# Hampshire Country Club Planned Residential Development

Village of Mamaroneck, Westchester County,  
New York

Date of Adoption April 6, 2020

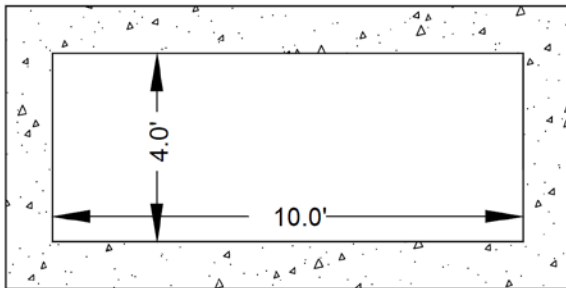
Proposed 100-year flowrate = 222 cfs

Assumed flow velocity = 6 ft/sec

$Q = AV$

$A = Q/v = 222/6 = 37 \text{ ft}^2$
